**Subject:** Pre-App LAND-2016-01420; 16390 Cleveland Street  
**Location:** Council Conference Room  
**Start:** Thu 9/1/2016 10:30 AM  
**End:** Thu 9/1/2016 11:30 AM  
**Show Time As:** Tentative  
**Recurrence:** (none)  
**Meeting Status:** Not yet responded  
**Organizer:** Gary Lee  
**Required Attendees:** Lisa Singer

# Pre-Application Form

Project Name: ~~Plot # 2016000000~~ Andorra  
 Project Address: 16340 Cleveland St. 98052  
 Parcel Number(s): 7198800085  
 Square Footage Site: 3140 Zone: \_\_\_\_\_  
 Acres: \_\_\_\_\_

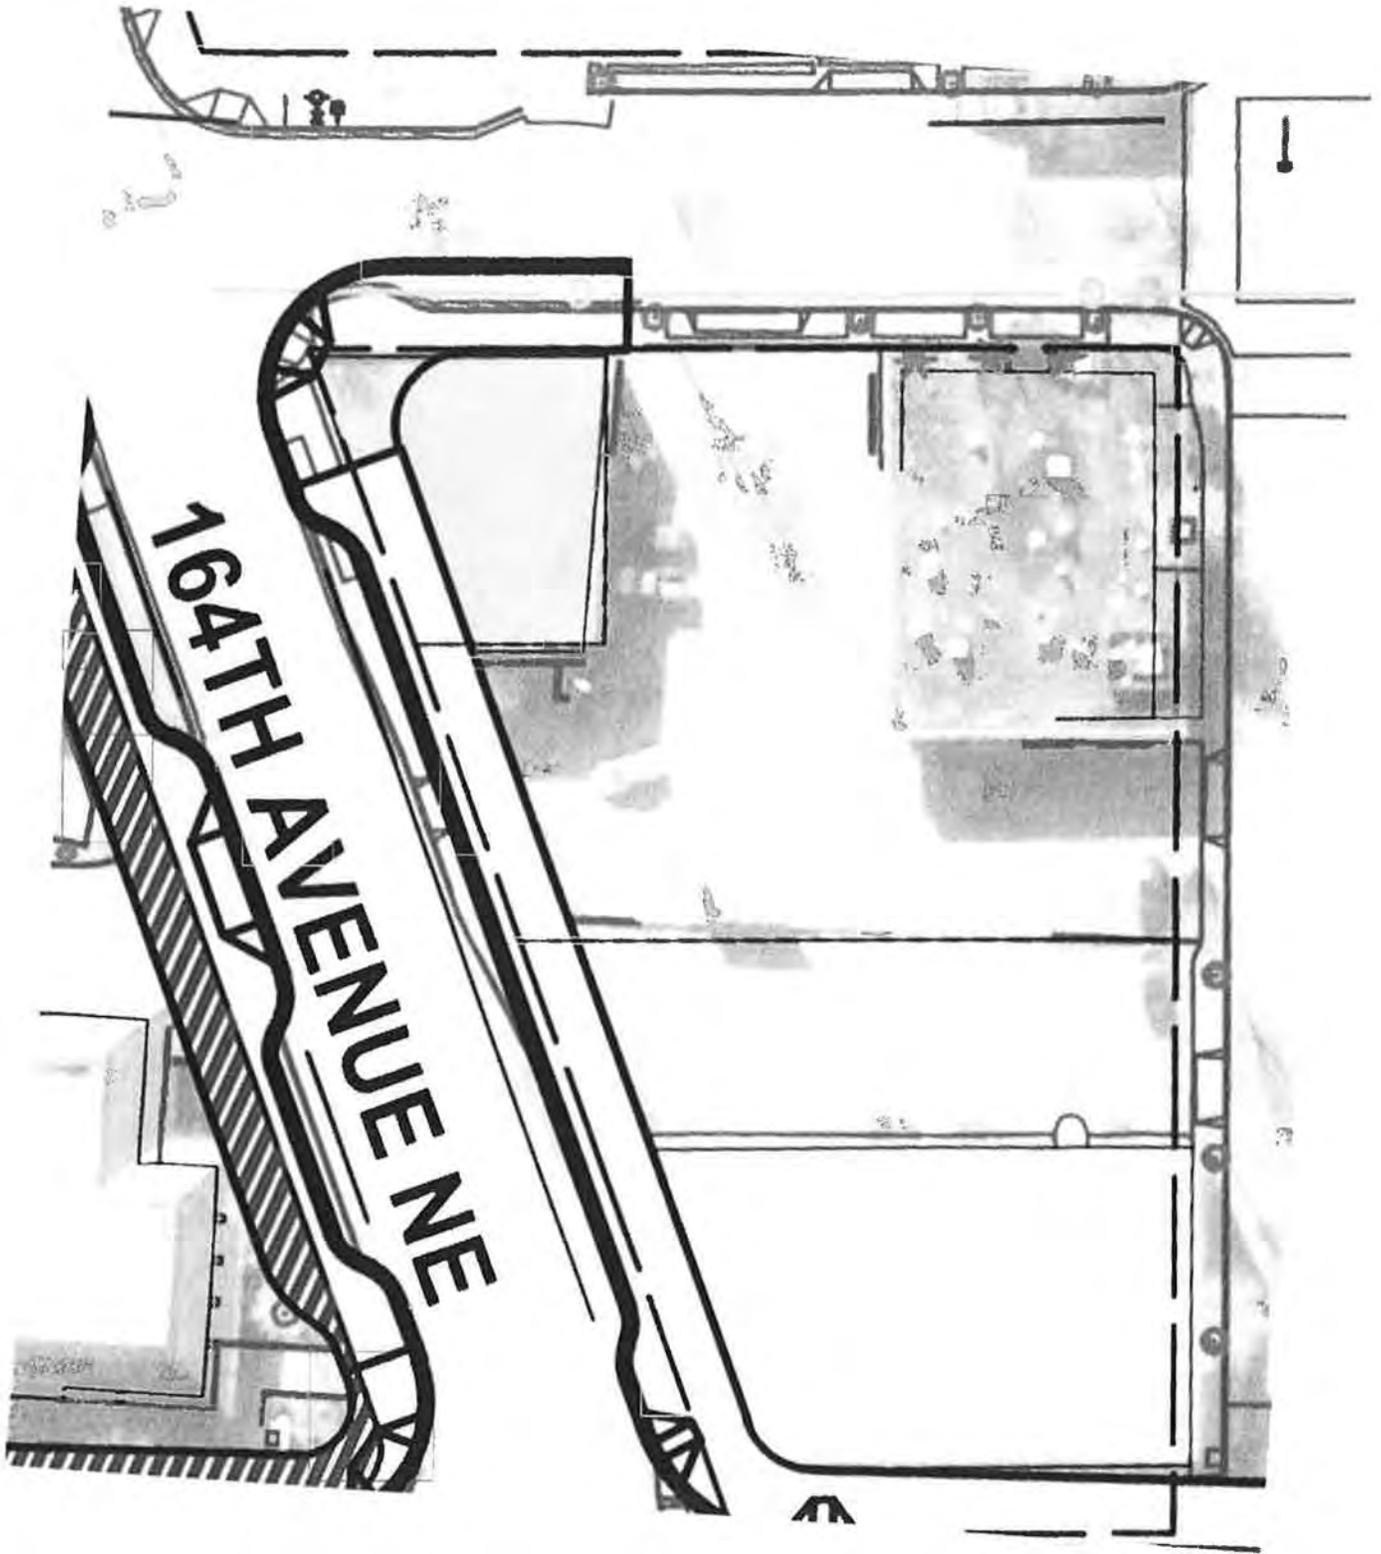
As mentioned by Min previously, you will need to do property frontage improvements, including new curb, gutter and sidewalk – according to City plans, if your improvements to the building equal or exceed the current assessed value of the improvements.

If the cost of the improvements to the building (with your project) equal or exceed \$23,500 (as assessed below) you will need to remove approximately 10' of the east side of the building (fronting 164<sup>th</sup> and the intersection) and build a new, wider, sidewalk as shown below. All of the costs associated with improving the building will be included.

Our general thinking is that you will be spending at least \$23,500 to make the building suitable for retail/commercial use, which will trip the requirement for the removal of the east side of the building and widening of the sidewalks. I think that this is very important for you to aware of.

Plans for this intersection call for the widening of the sidewalk as shown below. See arc through the building.
